CITY OF ALBUQUERQUE

Planning Department
Alan Varela, Director

**RE: 5100 Guadalupe Trail NW
Grading and Drainage Plan
Engineer's Stamp Date: 04/05/22
Hydrology File: F14D079**

ENGINEER'S SEAL  4/5/22 DAVID SOULE P.E. #14522	5100 GUADALUPE TRAIL	DRAWN BY: WCVJ
	GRADING AND DRAINAGE PLAN	DATE: 4-05-22
	 Rio Grande Engineering 1606 CENTRAL AVENUE SE SUITE 201 ALBUQUERQUE, NM 87106 (505) 872-0998	20220028-LAYOUT-4-05-22 SHEET # JOB # 20220028

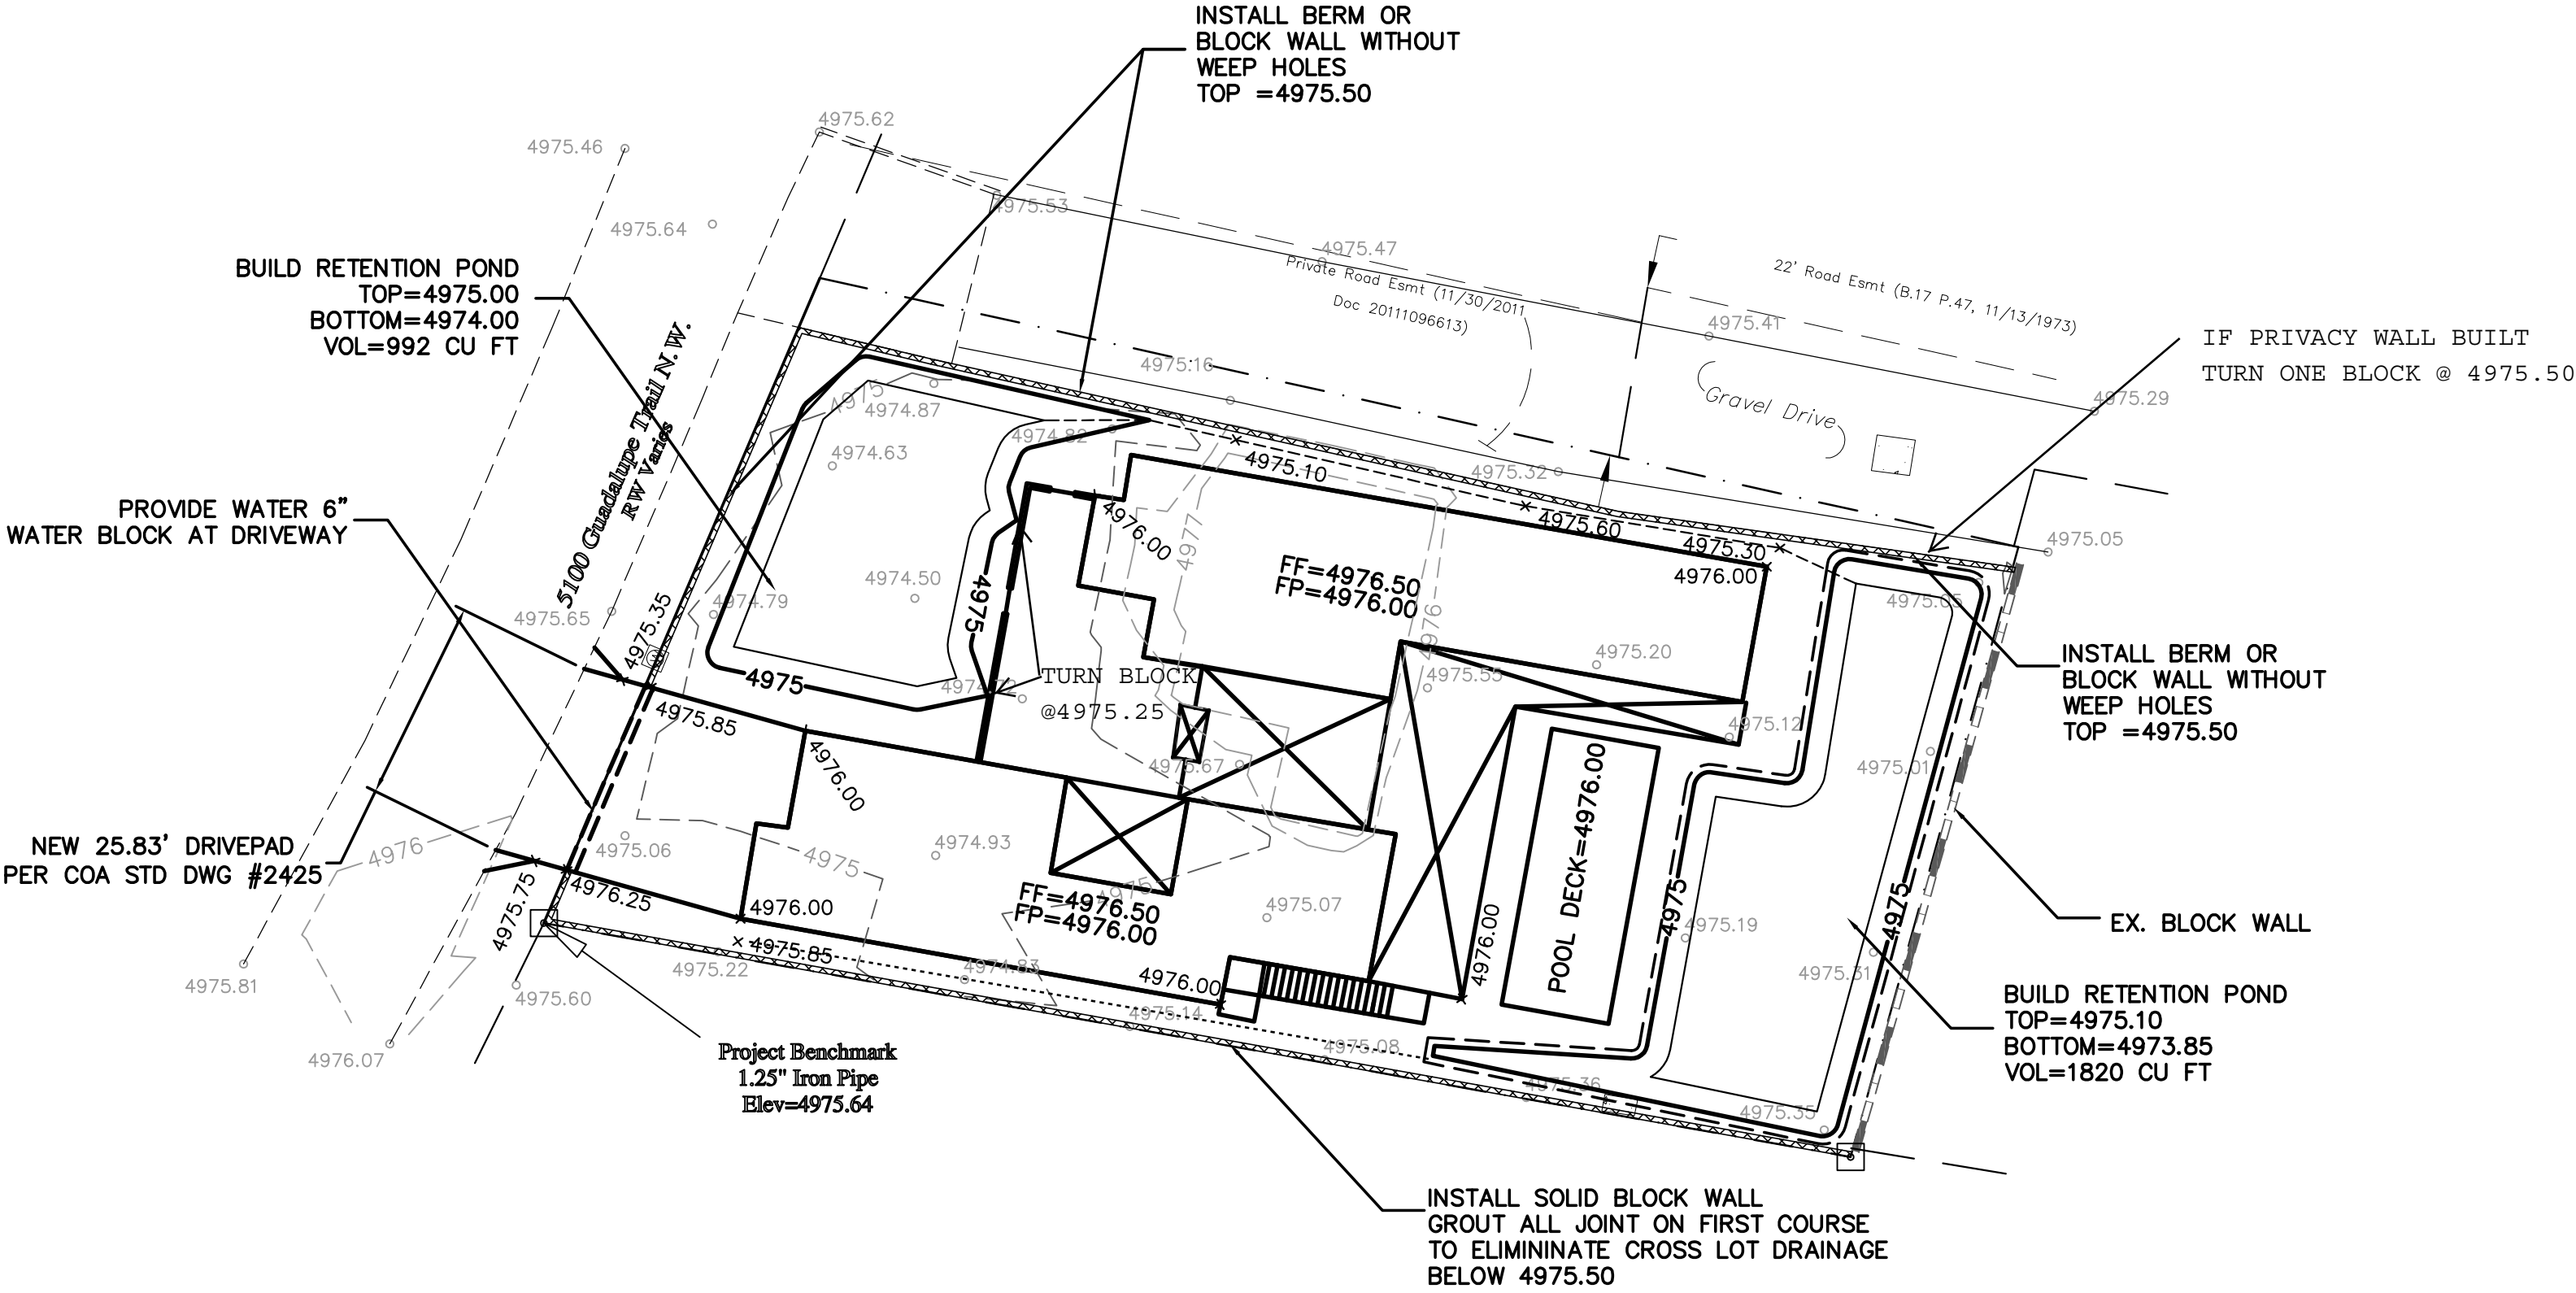
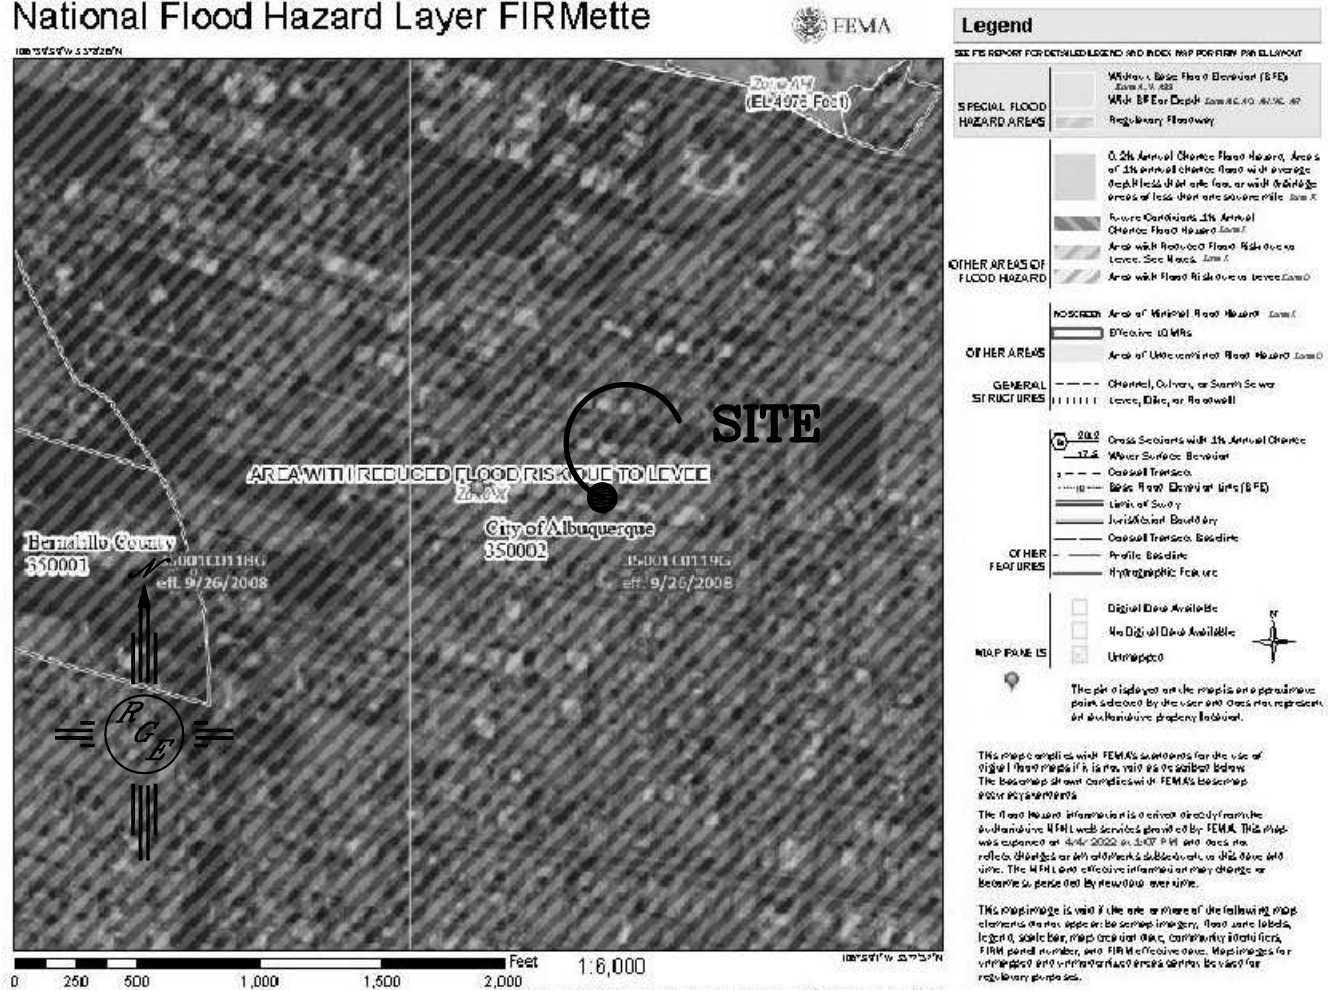
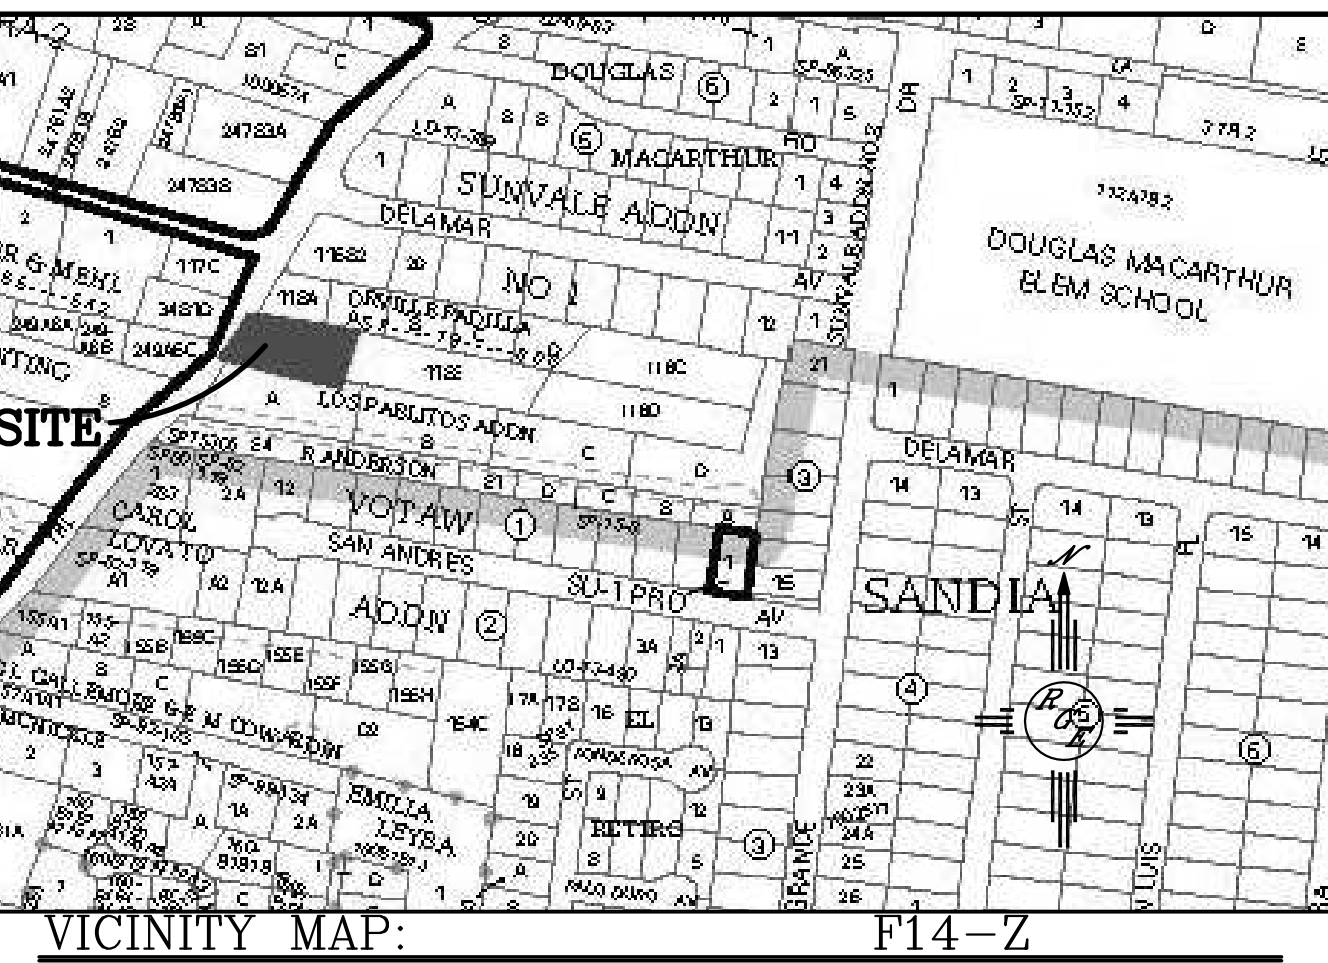
Based upon the information provided in your submittal received 04/05/2022, the Grading & Drainage Plan is approved for Grading Permit (earthwork can get started for the earth pad on the house).

1. Once the grading is complete, a pad certification (meaning that the earthwork is complete) will be required. Please include a site photo with the submittal. Also, at the time of pad certification approval, Hydrology will concurrently approve the Grading & Drainage Plan for Building Permit.
